L-2000-146  
10 CFR §50.90

Re: Turkey Point Units 3 and 4  
Docket Nos. 50-250 and 50-251  
Resubmittal of Proposed License Amendments  
"Revised Pressure-Temperature (P/T) Curves, and  
Cold Overpressure Mitigation System (COMS) Setpoints"

**DESCRIPTION OF PROPOSED AMENDMENTS**

FIGURE 3.4-2

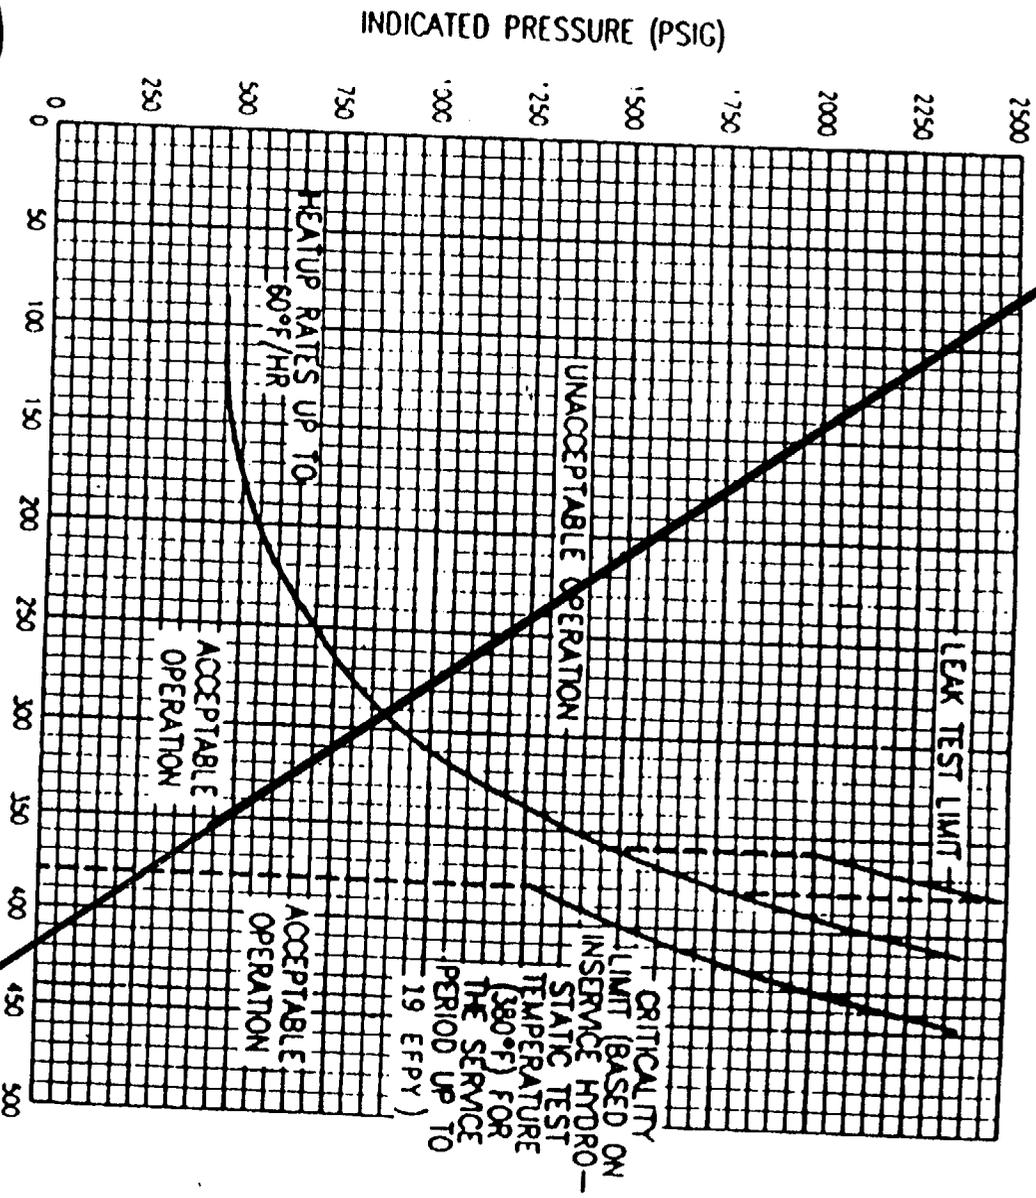
- b) **Technical Specification 3/4.4.9, Pressure/Temperature Limits: Delete reference to Figure 3.4-4.**

Discussion: The new heatup curves have the 60 °F/hour and 100 °F/hour rates on one figure. Deletion of Figure 3.4-4 is purely administrative.

**DELETE  
IN  
ENTIRETY**

FIGURE 3.4-2 Turkey Point Units 3 and 4 Reactor Coolant System Heatup Limitations (Heatup Rate of 60 and 100°F/hr) Applicable for 32 EPFY (Without Margins for Instrumentation Errors)

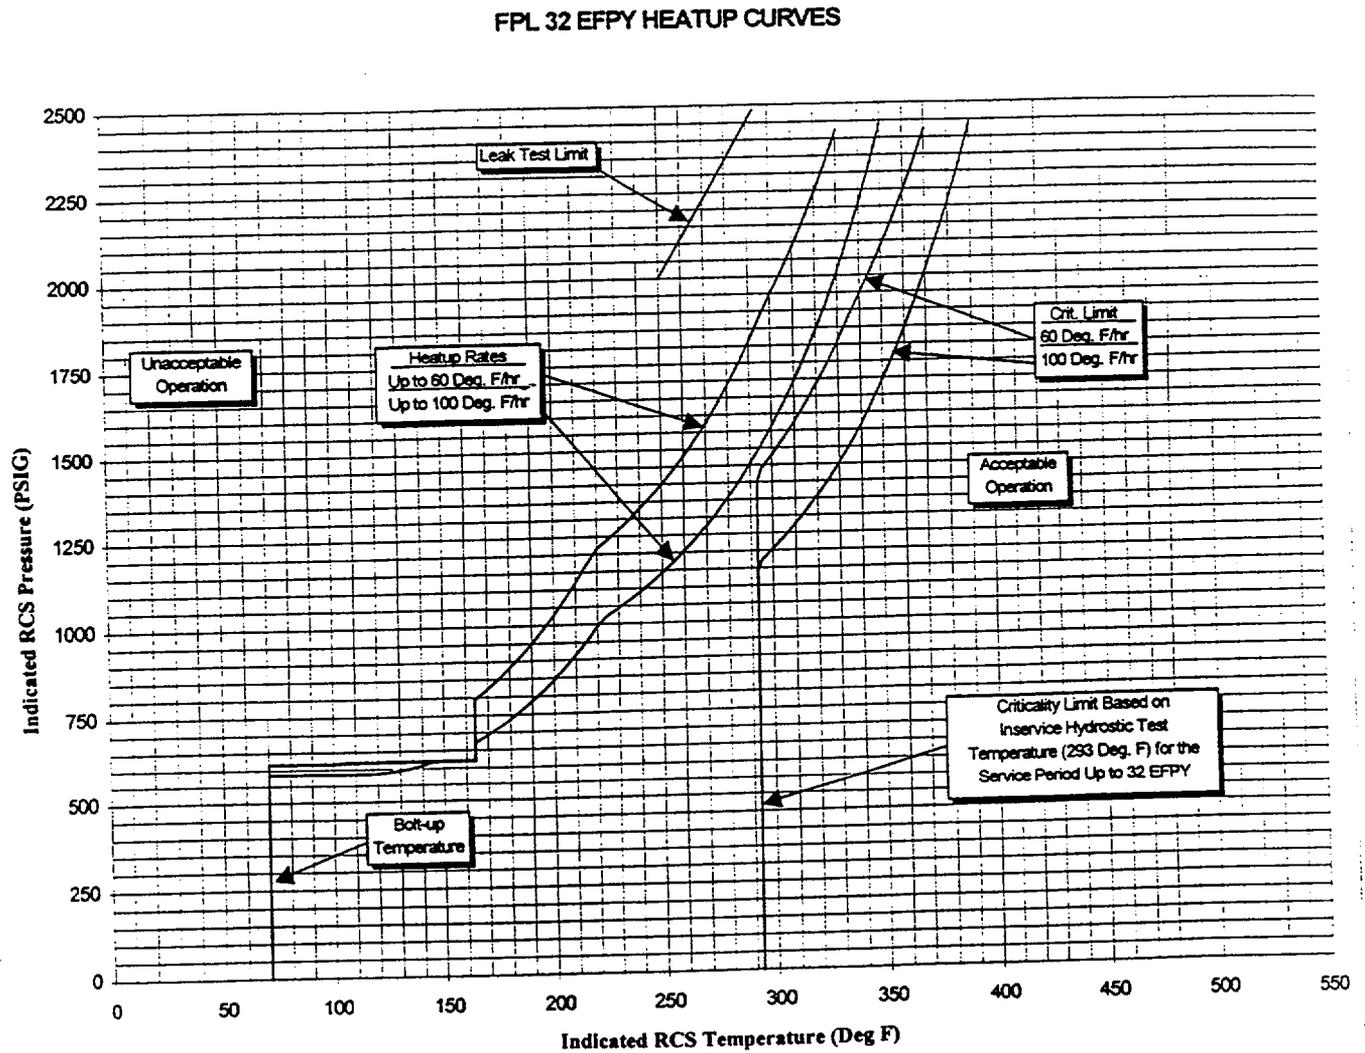
- c) **Technical Specification Figures 3.4-2, 3.4-3, and 3.4-4: Revise these figures to reflect the Pressure-Temperature Limits applicable for the service period up to 32 EFPY, as opposed to the present 19 EFPY.**

Discussion: The 32 EFPY curves replace the 19 EFPY curves. The new heatup curves have the 60 °F/hour and 100 °F/hour rates on one sheet. The 19 EFPY curves were separate for each heatup rate. The curves themselves have no instrument uncertainty built in but the associated LTOP setpoint does have the uncertainty margin included. The new curves are complete to minimum bolt-up temperature whereas the 19-year curves stopped at 80 °F. The 32 EFPY curves have a compound slope which shows the effect of Code Case N-588. This slope reflects the fact that at low temperatures the forging with its assumed longitudinal reference flaw dominates because hoop stress dominates. The weld is limiting for most of the range.

LIMITING ART VALUES AT 32 EPFY: 1/4T, 262°F

3/4T, 218°F

FIGURE 3.4-3

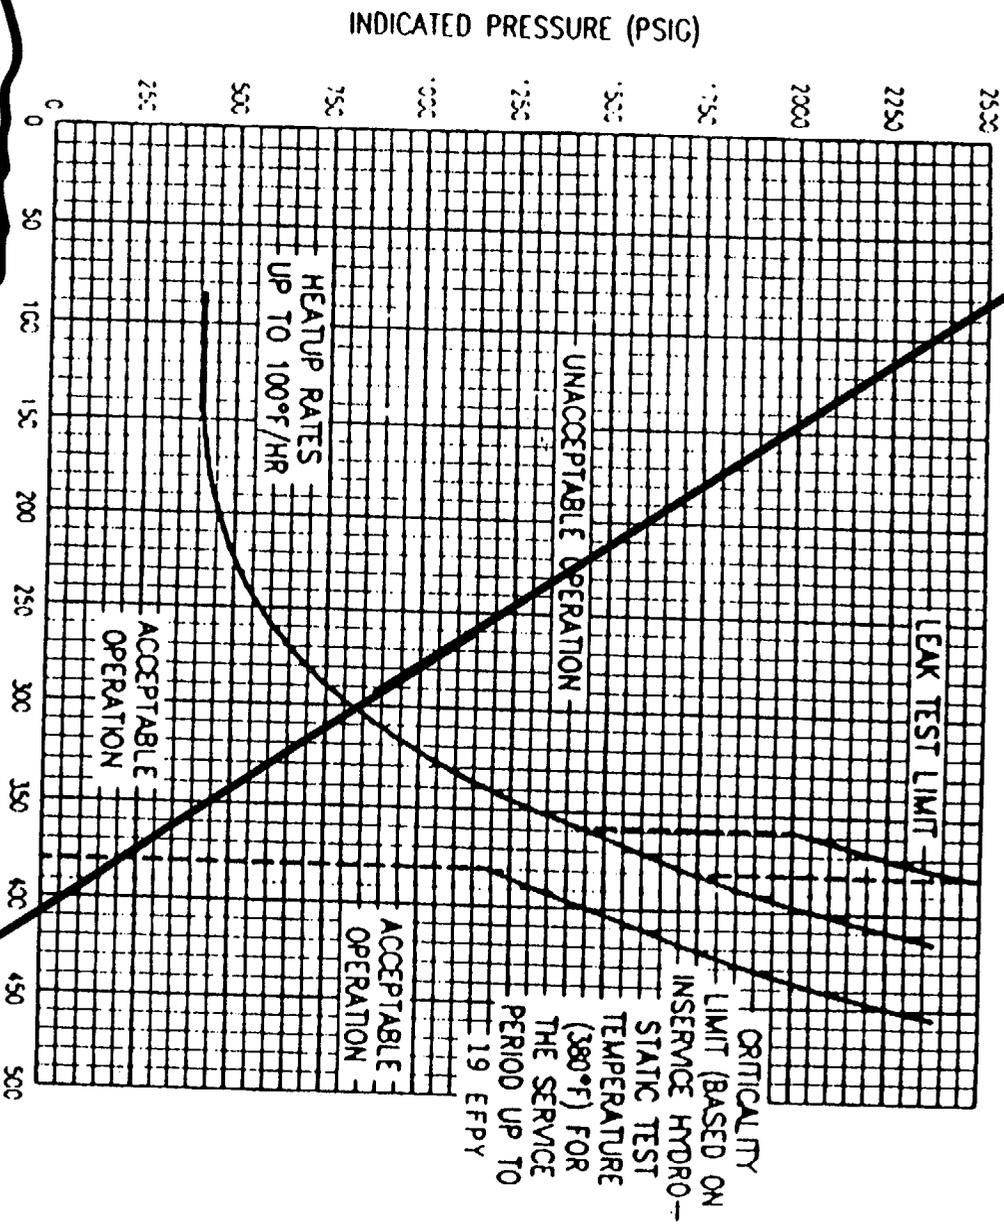
**DELETE  
IN  
ENTIRETY**

FIGURE 3.4-4

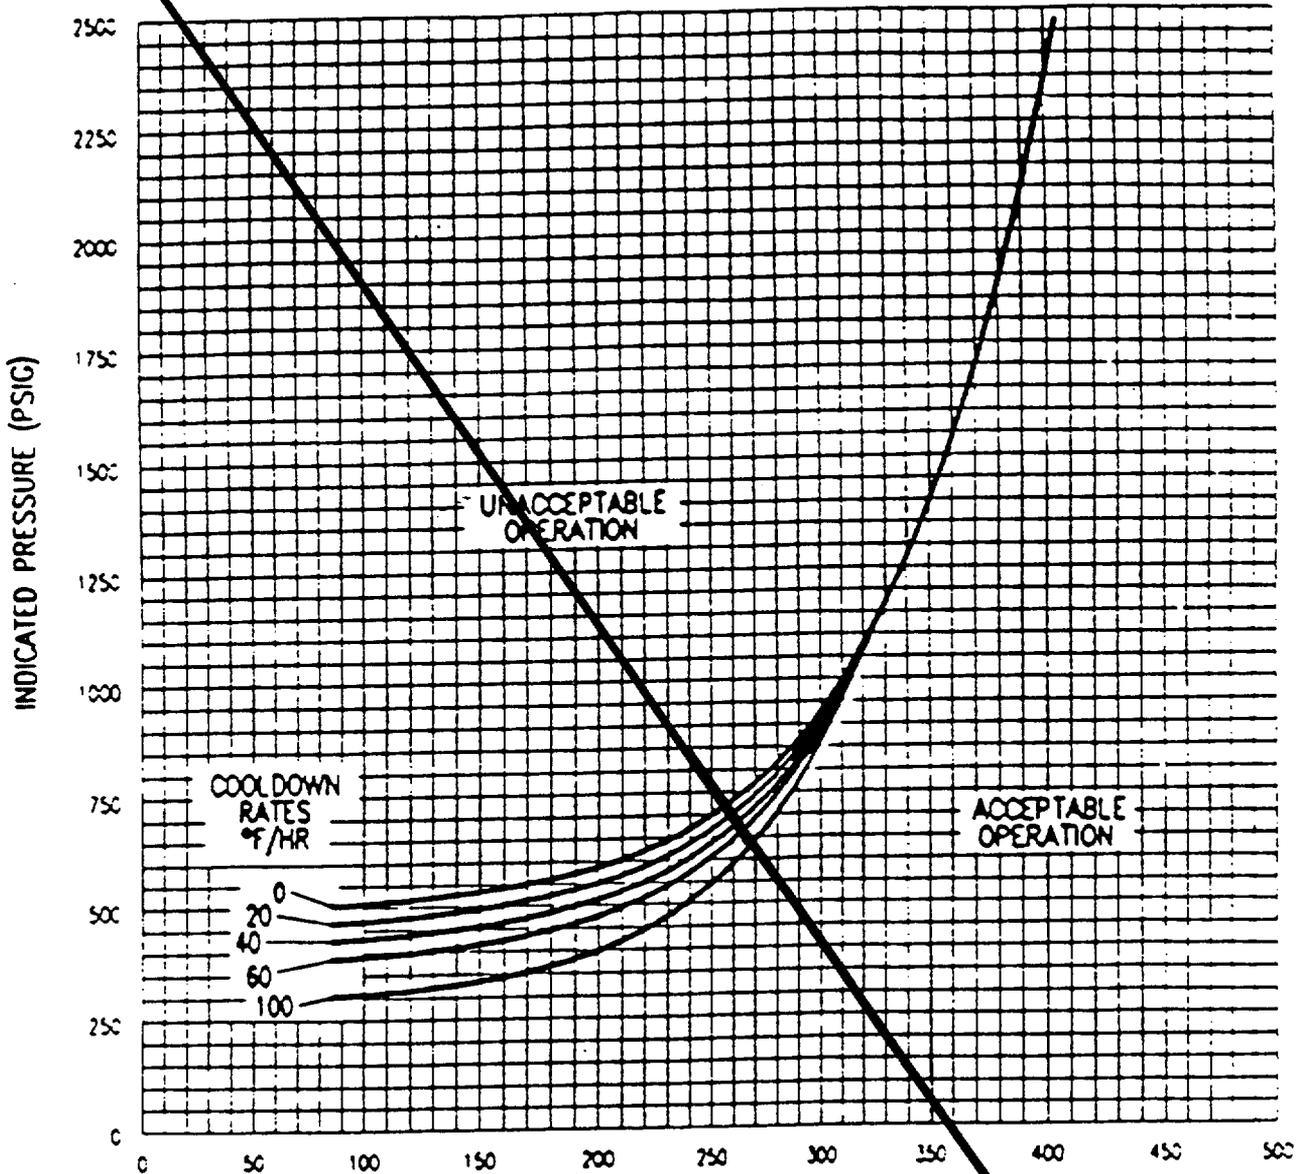
**DELETE IN ENTIRETY**
